<p>CDM: FORM FOR SUBMISSION OF A “LETTER TO THE BOARD” (Version 01.2)</p> <p>This form should be used only by project participants and other stakeholders for submitting a “Letter to the Board” in accordance with the latest version of the <i>Modalities and procedures for direct communication with stakeholders</i></p>	
Name of the stakeholder ¹ submitting this form (individual/organization):	Martin Stilkenbäumer Dr. Marten von Velsen-Zerweck N.serve Environmental Services GmbH
Address and contact details of the individual submitting this form:	Address: Gr. Theaterstr. 14, 20354 Hamburg, Germany Telephone number: +49 40 30997860 E-mail address: Stilkenbaeumer@nserve.net ; velsen@nserve.net ;
Title/Subject (give a short title or specify the subject of your submission)	Letter with respect to next EB Meeting 66: Strong recommendation to <u>NOT</u> accept the final response of the MP to request AM_REV_0227 concerning the approved methodology ACM0019 N2O abatement from nitric acid production and NOT to approve the proposed revision to the approved methodology ACM0019

Meth panel Meeting 23 - 27 January 2012**Revision of project emissions calculation AM_REV_0227****Revised methodology as an

Graph 1:

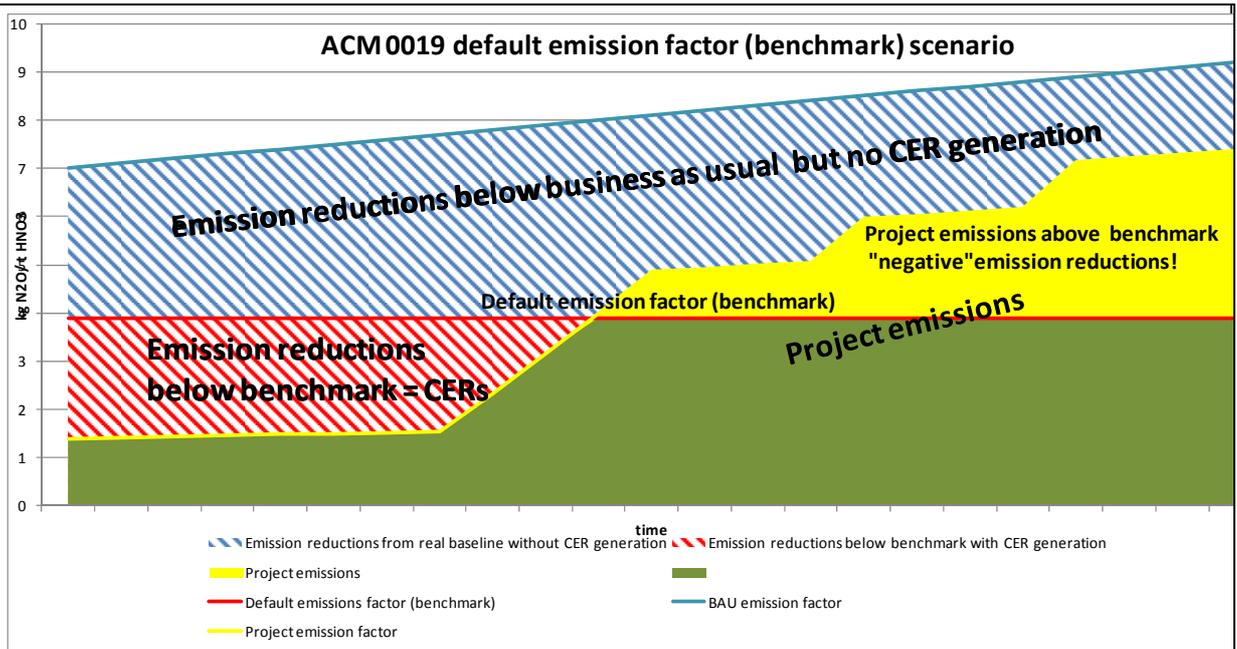
Under the project activity of the approved methodology ACM0019 no GHG emissions are caused by implementation of secondary catalyst systems as project activity. Therefore the project emissions do not exceed the baseline emissions or business as usual emissions (s. graph 1 below): although the project emissions exceed the default N₂O emission factor ("Benchmark") (red line) no "negative emissions" occur, because the project activity emissions are nevertheless below or - in the worst case - at the same as the real baseline (blue line). In difference to other project types the project activity itself does not produce any emissions that could exceed the baseline (blue line). It needs to be clearly distinguished between the "benchmark (default baseline)" and the original baseline (historic emission level). Therefore no negative emission reductions as suggested in the answer by the Meth Panel occur in this project type and it is not justified to limit the periods where the emission reductions could be considered zero as suggested in the answer by the Meth Panel.

For any hours during which the measured N₂O emissions are higher than the given default baseline emissions factor, the project emissions should be set equal to the applicable benchmark/ baseline emissions factor. This will result in no CERs generated during such times.
